SUBJECT: NORTH ANNA POWER STATION, UNITS 1 AND 2 - ISSUANCE OF
AMENDMENTS AND EXEMPTION FROM THE REQUIREMENTS OF
10 CFR PART 50, SECTION 50.60(a) RE: AMENDED PRESSURE-
TEMPERATURE LIMITS (TAC NOS. MA9343, MA9344, MA9347, AND MA9348)

Amendment No. 226
License No. NPF-4

Amendment No. 207
License No. NPF-7

SAFETY EVALUATION BY THE OFFICE OF NUCLEAR REACTOR REGULATION
RELATED TO THE PRESSURE-TEMPERATURE LIMITS AND LOW TEMPERATURE
OVERPRESSURE PROTECTION SYSTEM FOR
NORTH ANNA POWER STATION UNITS 1 AND 2
VIRGINIA ELECTRIC AND POWER COMPANY (VEPCO)
DOCKET NOS. 50-338 AND 50-339

Figure 3.4-2

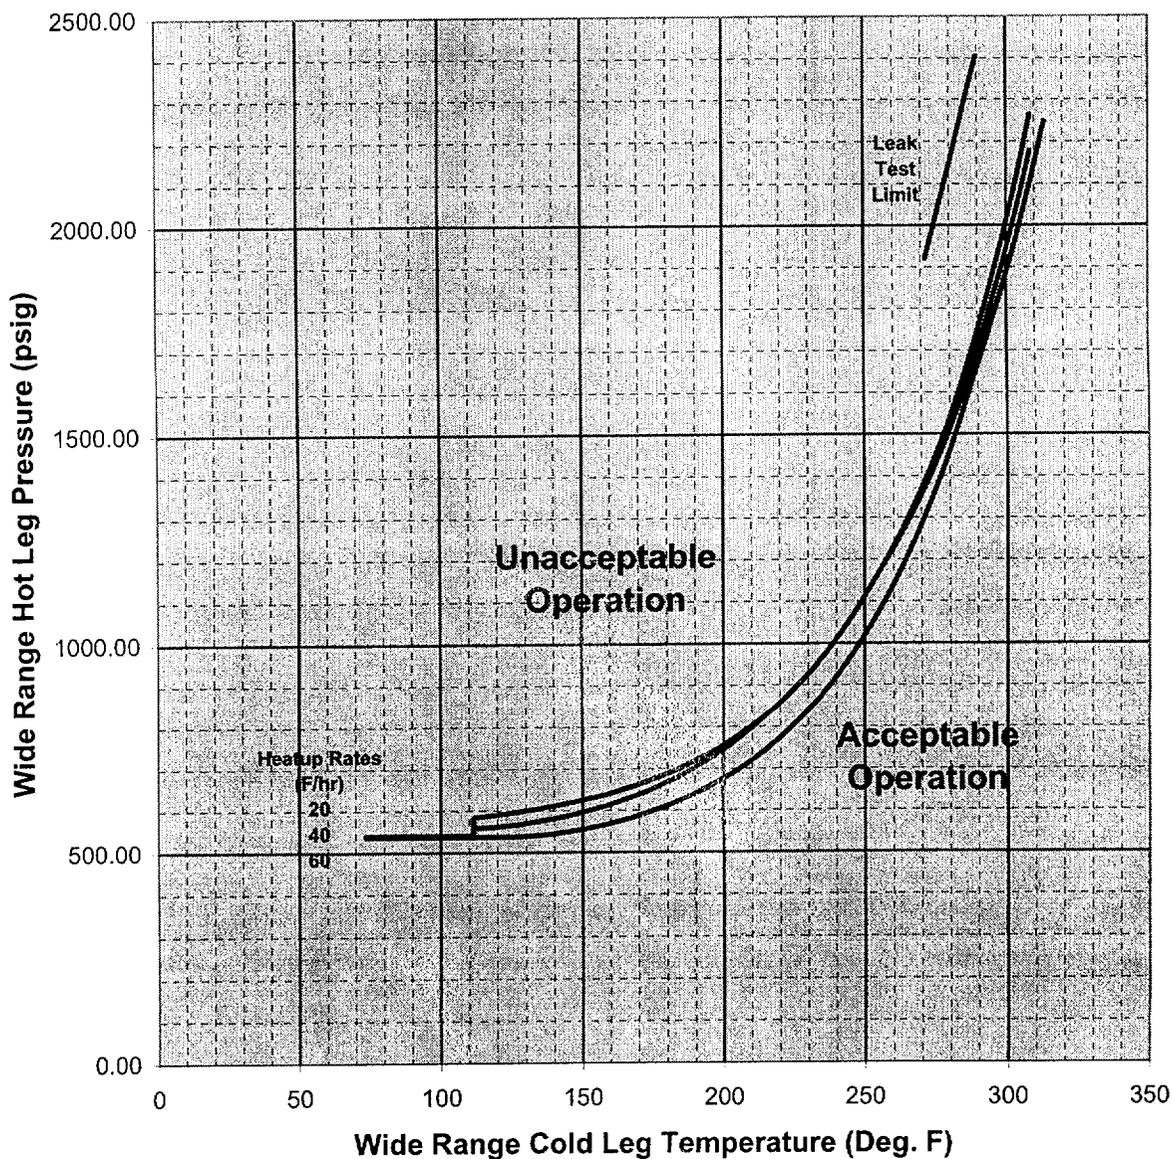
The heatup limit curve, Figure 3.4-2, is a composite curve which was prepared by determining the most conservative case, with either the inside or outside wall controlling, for any heatup rate up to 60°F per hour. The cooldown limit curves of Figure 3.4-3 are composite curves which were prepared based upon the same type analysis with the exception that the controlling location is always the inside wall where the cooldown thermal gradients tend to produce tensile stresses while producing compressive stresses at the outside wall. The heatup and cooldown curves of Figures 3.4-2 and 3.4-3 are based upon a 1/4-T RT_{NDT} value of 218.5°F and a 3/4-T RT_{NDT} value of 195.6°F. These RT_{NDT} values conservatively bound the predicted reactor vessel beltline RT_{NDT} values for North Anna Unit 1 operation through 32.3 EFPY. The heatup and cooldown limits include margins to accommodate pressure and temperature measurement uncertainty, and the pressure difference between the point of measurement (RCS hot leg) and the point of interest (reactor vessel beltline).

The pressure-temperature limit lines shown on Figure 3.4-2 for inservice leak and hydrostatic testing have been provided to assure compliance with the minimum temperature requirements of Appendix G to 10 CFR 50. The minimum temperature for criticality specified in T.S. 3.1.1.5 assures compliance with the criticality limits of 10 CFR 50 Appendix G.

Figure 3.4-2

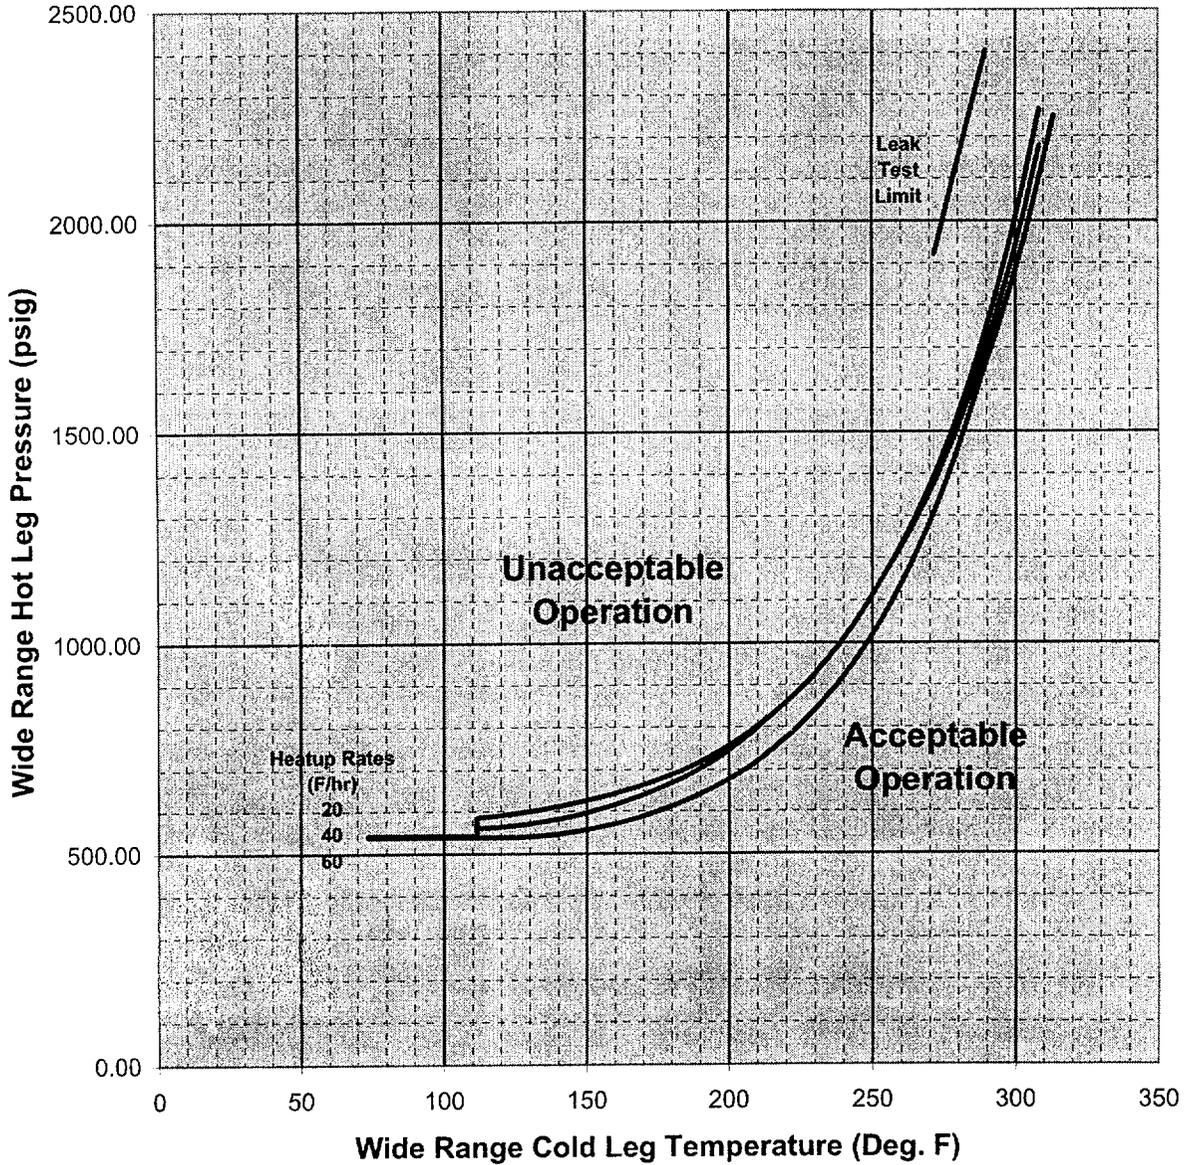
The heatup limit curve, Figure 3.4-2, is a composite curve which was prepared by determining the most conservative case, with either the inside or outside wall controlling, for any heatup rate up to 60°F per hour. The cooldown limit curves of Figure 3.4-3 are composite curves which were prepared based upon the same type analysis with the exception that the controlling location is always the inside wall where the cooldown thermal gradients tend to produce tensile stresses while producing compressive stresses at the outside wall. The heatup and cooldown curves of Figures 3.4-2 and 3.4-3 are based upon a 1/4-T RT_{NDT} value of 218.5°F and a 3/4-T RT_{NDT} value of 195.6°F. These RT_{NDT} values conservatively bound the predicted reactor vessel beltline RT_{NDT} values for North Anna Unit 2 operation through 34.3 EFPY. The heatup and cooldown limits include margins to accommodate pressure and temperature measurement uncertainty, and the pressure difference between the point of measurement (RCS hot leg) and the point of interest (reactor vessel beltline).

The pressure-temperature limit lines shown on Figure 3.4-2 for inservice leak and hydrostatic testing have been provided to assure compliance with the minimum temperature requirements of Appendix G to 10 CFR 50. The minimum temperature for criticality specified in T.S. 3.1.1.5 assures compliance with the criticality limits of 10 CFR 50 Appendix G.
